Service-Information

Group: 11 Engine	November 1982	Bulletin No.: 11 019 81 (2031)
---------------------	------------------	-----------------------------------

RE: ENGINE MODIFICATIONS

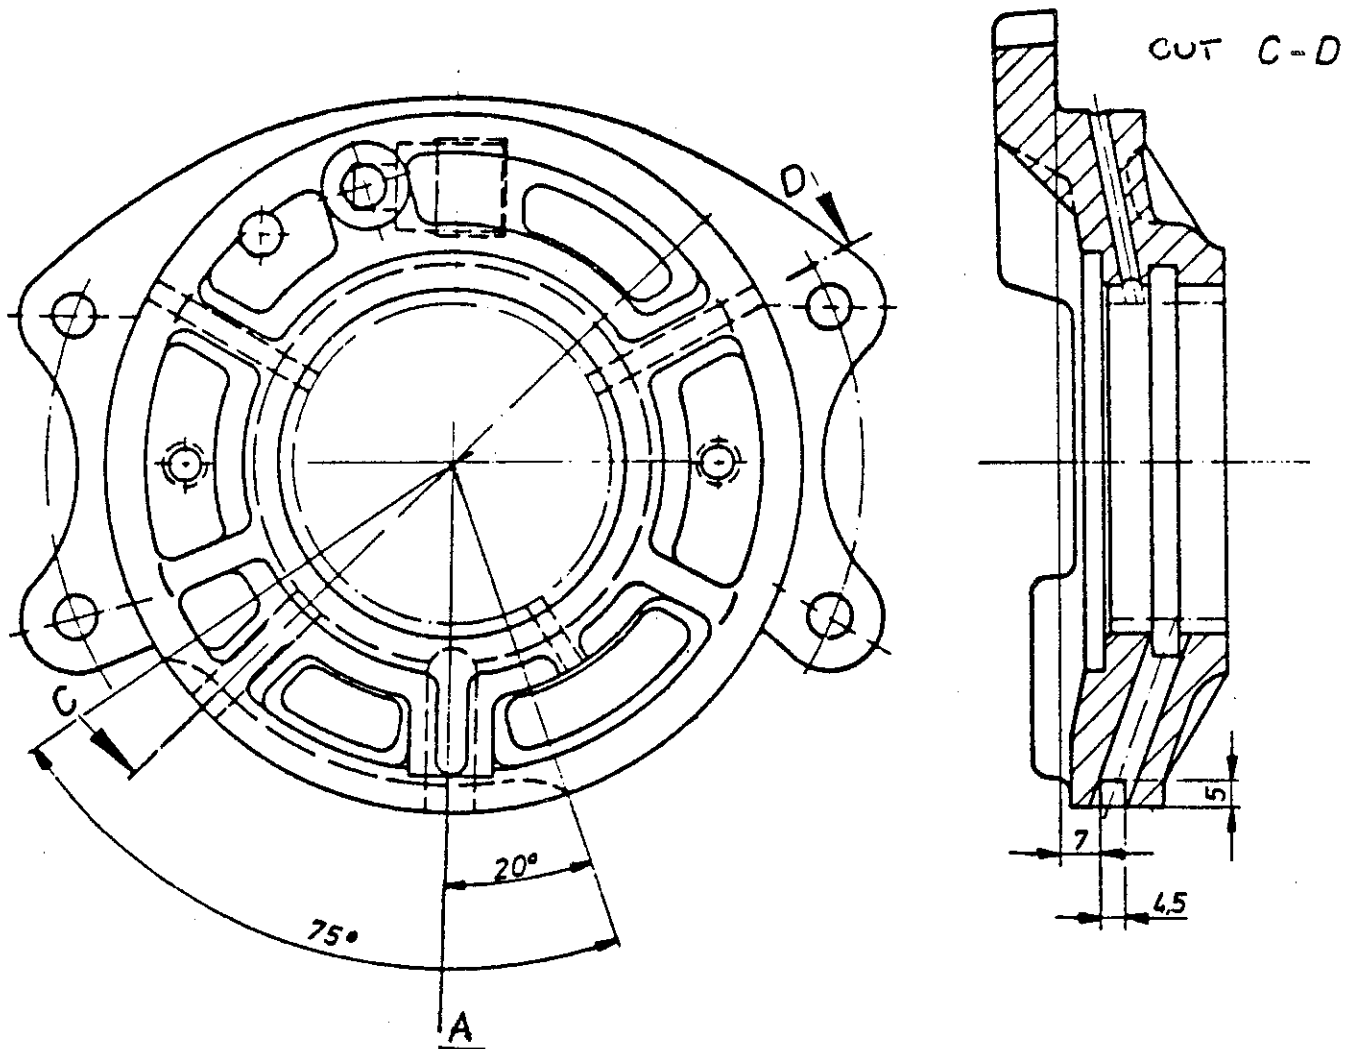
When an "Alcan" crankcase is used as a replacement on models which utilize a duplex (double row) timing chain camshaft drive (models 1970 to 1978), you must do one of two things:

- (1) replace the front main bearing holder with a new design, part No. 11 11 1 259 593,
- (2) modify the existing main bearing holder to provide an oil distribution passage on the outer edge.

If you choose to modify the main bearing holder rather than replace it, use drawing below:

If the above-mentioned modification or exchange is not done, no oil pressure will be obtained.

When an "Alcan" crankcase is used as a replacement on models produced before the above-listed VIN numbers that utilize a single row timing chain camshaft drive system (models 1979-1980), the only modification required (assuming that the outer distribution passage exists) is to ensure that the oil passageway A (found on Diagram #1) has a minimum diameter of 6.2 mm \varnothing . If it does not, you must enlarge it to this figure or replace it with part No. 11 11 1 337 293 main bearing holder.
